DRAFT Planning Commission Motion NO. M-XXXXX

ADOPTING FINDINGS RELATED TO THE CERTIFICATION OF THE FINAL ENVIRONMENTAL IMPACT REPORT FOR THE PROPOSED ALAMEDA CREEK RECAPTURE PROJECT.

PLANNING DEPARTMENT
CASE NO. 2015-004827ENV
STATE CLEARINGHOUSE NO. 2015062072
APRIL 1, 2020

This Supplemental Responses to Comments document is Volume 5 of the environmental impact report (EIR) on the San Francisco Public Utilities Commission's (SFPUC) Alameda Creek Recapture Project (ACRP or proposed project). It contains written responses to comments on the Recirculated Portions of the Draft EIR (Volume 4) published by the San Francisco Planning Department on December 4, 2019. The comments were submitted to the planning department during the public review period from December 5, 2019 through January 21, 2020, either in writing or in public testimony during the public hearing on January 9, 2020. The purpose of this document is to complete the Final EIR on the ACRP in compliance with the requirements of the California Environmental Quality Act (CEQA) (California Public Resources Code sections 21000 et seq.), CEQA Guidelines (California Code of Regulations, Title 14, sections 15000 et seq.), and San

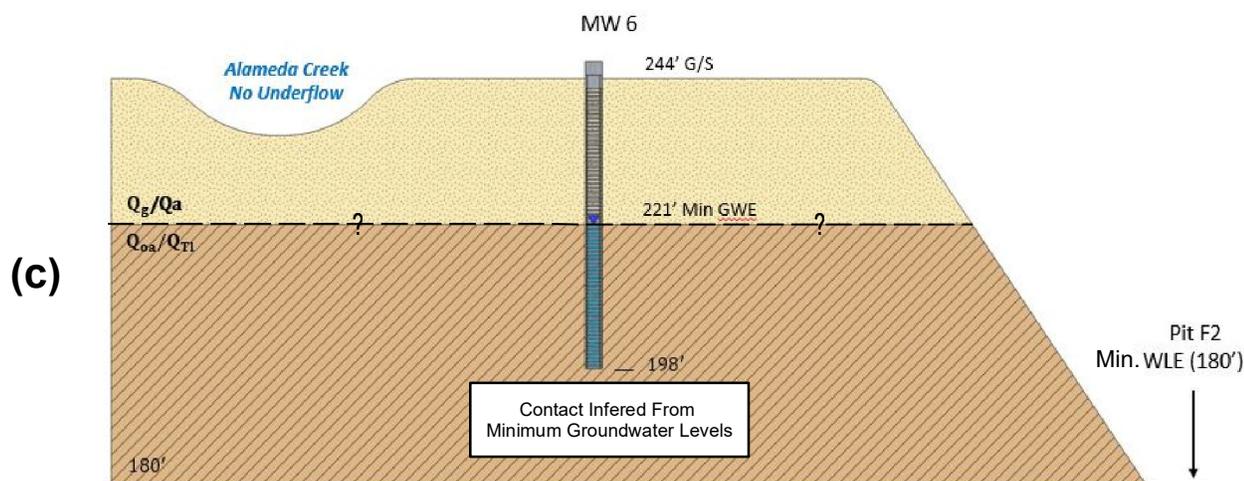
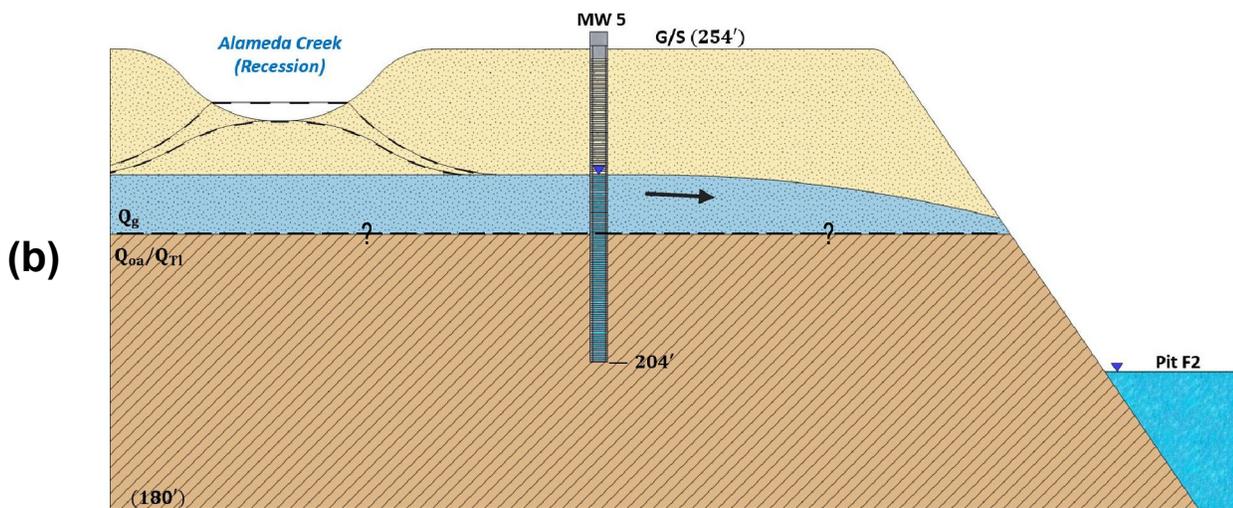
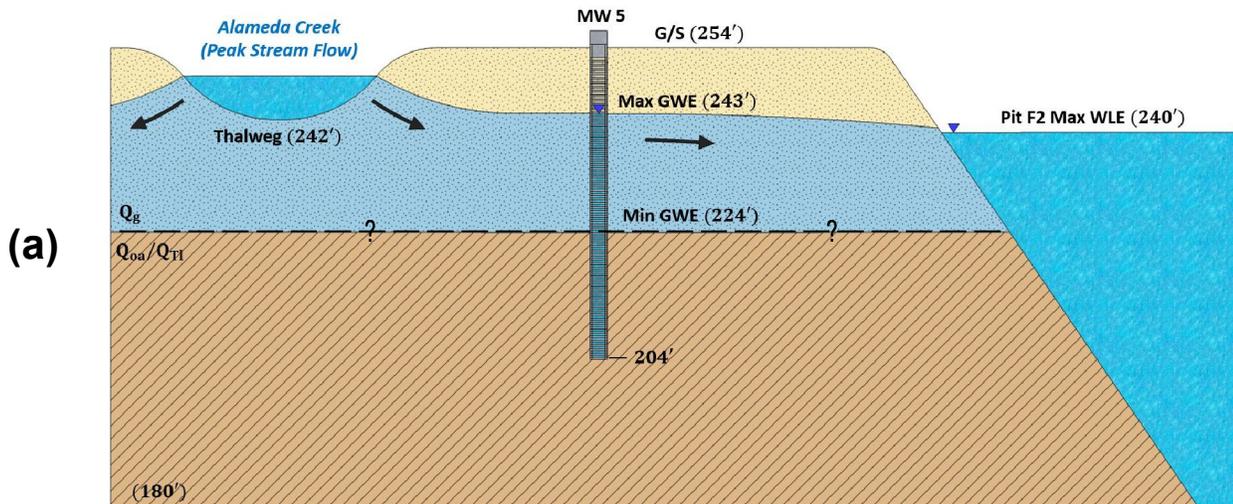
-
4. “Lastly, as noted in our November 12, 2019 email, Luhdorff & Scalmanini (LSCE) estimated that average groundwater inflow to Pit F-2 is 4.67 cfs (revised DEIR Appendix HYD2 Figure 9-9). However, the proposed rate of pumping from Pit F-2 is on average 6,045 AFY, which is equivalent to a constant flow of about 8 cfs, or nearly twice the average rate of inflow.

Can you please provide an explanation of the path through which the increased streamflow is assumed to travel into Pit F2 and which would allow for this additional pumping?” (*Robert Shaver, General Manager, Alameda County Water District, letter, December 18, 2019 [A-ACWD3-4]*)

Comment A-ACWD3-4 requests an explanation of the path through which the increased streamflow is assumed to travel into Pit F2. While the implementation of CDRP releases will increase the volume of water in the creek, and therefore the volume of water entering Pit F2, the pathways by which water enters Pit F2 remain unchanged from the existing condition. These pathways are best depicted in Figure HYD4-3 in Appendix HYD1-R and Figure 7-4 in Appendix HYD2-R. Figure HYD4-3 is a simplified schematic showing the various pathways of water entering and leaving Pit F2. Key inputs into the pit are labeled (A) through (C); inputs and outputs deemed constant between scenarios (e.g., precipitation and evaporation) are not shown. As evident in the figure, water enters the pit through three primary pathways: as subsurface flow from upstream quarry pits (A), as runoff from the small watershed to the east of the pit (B), and as direct seepage from Alameda Creek between the cutoff walls surrounding the pit (C). Figure 7-4 from Appendix HYD2-R illustrates the mechanism by which direct seepage into Pit F2 from Alameda Creek occurs.

As described in Appendix HYD2-R, pp. 22 to 23, Figure 7-4 is a three part cross-sectional schematic of Alameda Creek in the vicinity of monitoring well 5, just upstream of Pit F2, under various conditions. Figure 7-4(a) shows the conditions with maximum observed groundwater levels and maximum storage levels in Pit F2; Figure 7-4(b) shows the recession of groundwater with declining streamflow, and Figure 7-4(c) shows the minimum observed groundwater level corresponding to the interpreted base of the shallow aquifer. Under conditions shown in Figure 7-4(a) and (b), subsurface water in the shallow aquifer would flow towards Pit F2. Figures HYD4-3 and 7-4 are reproduced on the following two pages.

Comment A-ACWD3-4 includes some misleading information. The commenter is correct in stating that the EIR analysis estimated that average groundwater inflow to Pit F2 is 4.67 cfs (see Appendix HYD2-R, Section 9.3.2 and Figure 9-9(a)). This average value applies only to the 14-month period from December 2014 to January 2016, which was used to quantify the mass balance calculation for Pit F2. This period was selected for the mass balance analysis because there were no quarry operator additions to the pit, which are otherwise unmonitored; this period also coincided with a significant statewide drought. The commenter, however, makes the misleading

Figure 14-4

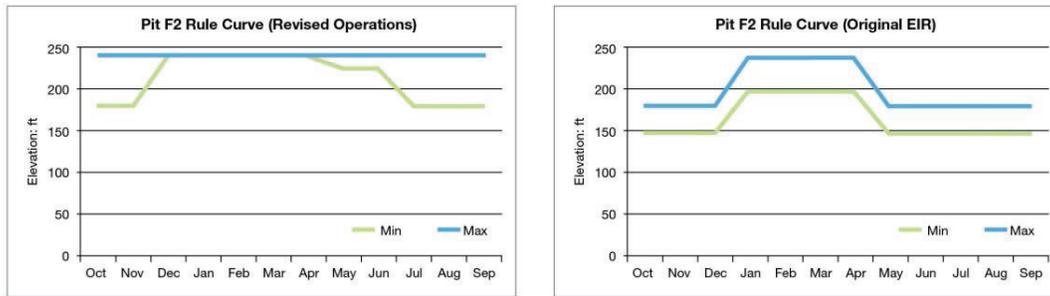
More specifically, section 14.2 provides a revised construction schedule, and section 14.3 describes the revised project operations, including recapture volumes and operating parameters. Figure 14-2 provides a schematic of the revised ACRP operations set forth in the REIR compared to the operations described in the June 2017 Environmental Impact Report, demonstrating that the revised project operational protocols set forth in the REIR have a reduced operational pumping period and higher Pit F2 water levels below
